Appendix I1
Accessibility
Audit Report

Jacobs Engineering Ireland Limited

As a part of the Engineering Design Services for the Preliminary Design and Planning Stage, through to the end of the Statutory Process of the BusConnects Radial Core Bus Corridors Infrastructure Programme, an audit of the existing infrastructure provided for people with disabilities along the proposed Bray to City Centre Core Bus Corridor (CBC) has been carried out. This report outlines the standards and guidelines that should be used to provide suitable infrastructure for people with disabilities, the process and outcomes of the audit and recommended improvements that will bring the existing infrastructure up to standard.

Figure 2.7: Missing tactile paving

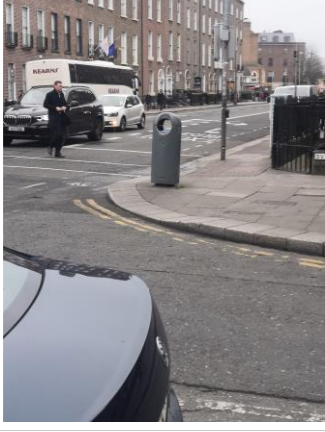
While all the tactile paving in this section appears to be of the correct layout, the western arm of Greenfield Park is missing tactile paving, as in

Figure 3.3: Sections of the scheme with no continuous footpath

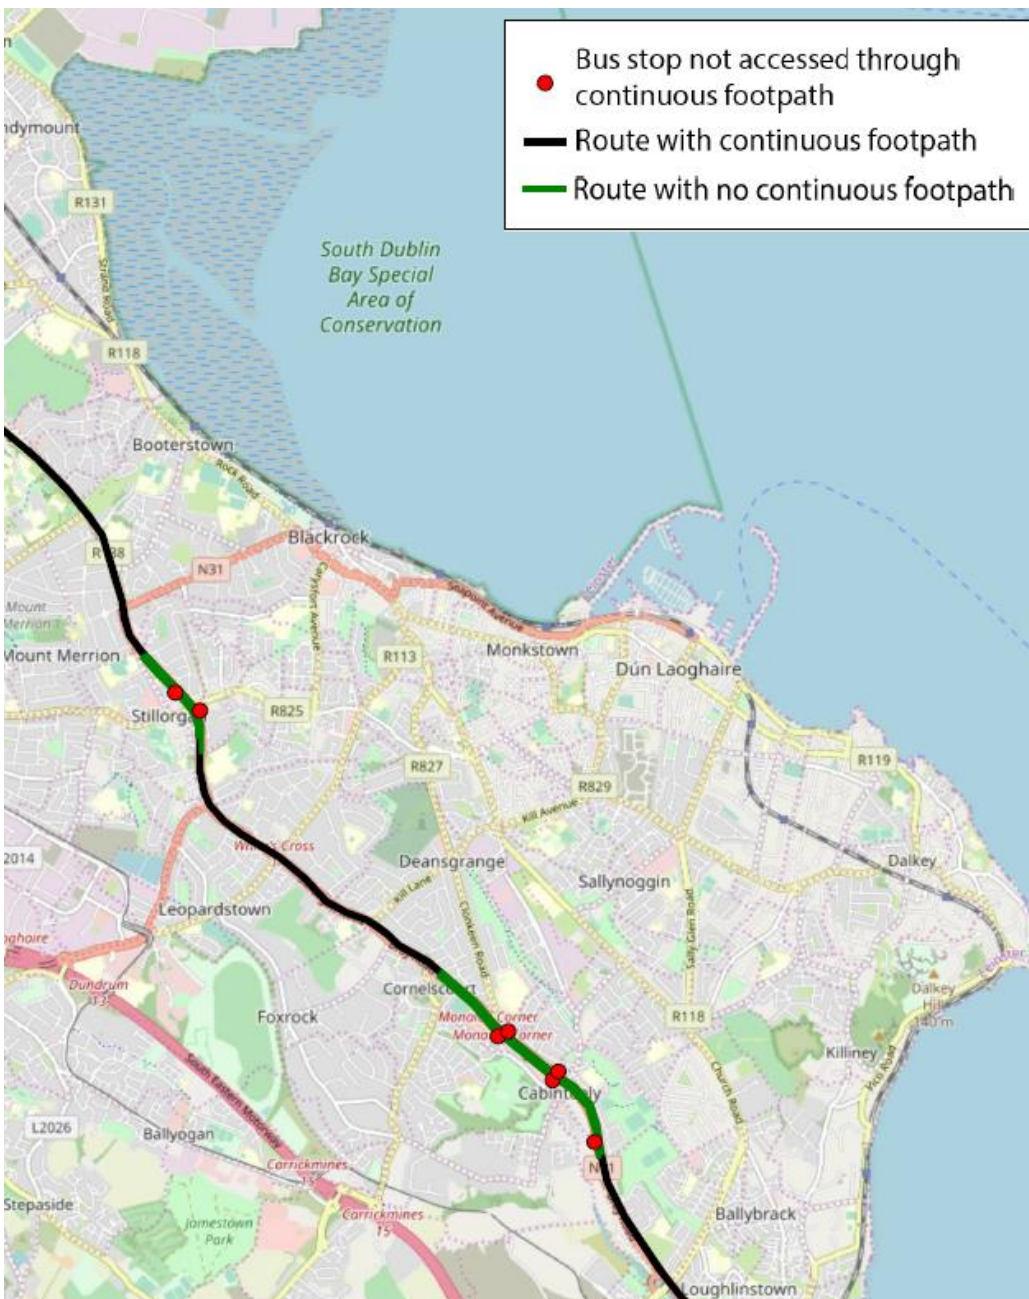
Figure 3.3 shows the section of the scheme within this section where there is no continuous footpath provided by design. These sections have either a crossing provided to the footpath on the other side, or a footway on a parallel street away from the main road, with path access to the bus stops.

Figure 3.4: Lamp post in footway

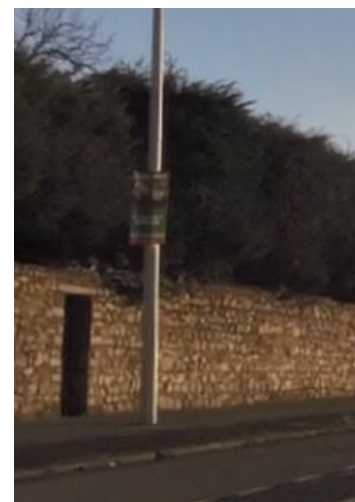
The footpath and kerbing along this section appears to be mostly of good quality throughout this section. There are two instances on the video where lamp posts appear to limit the width of the footpath below the standards allowed, Figure 3.4. It is recommended that in the design stage, all lamp posts are placed at the edge of the footpath or away from the footpath completely, where considered to limit the width of the footpath below the standards allowed.

Figure 5.4: Inappropriate bus stop

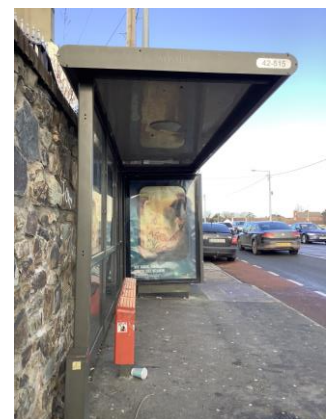
The footpath issues account for just over half of the issues identified in Section 4. Of these, there are 19 instances of broken or uneven footpath, six instances of broken kerbing, two instances of ponding and 26 inappropriately constructed vehicle crossover points. There are two sections where no footpath is provided at all, three sections of footpath are of insufficient width and there are three cases of inappropriate street furniture, such as the bus stop in Figure 5.4 which limits the footpath width to less than required.
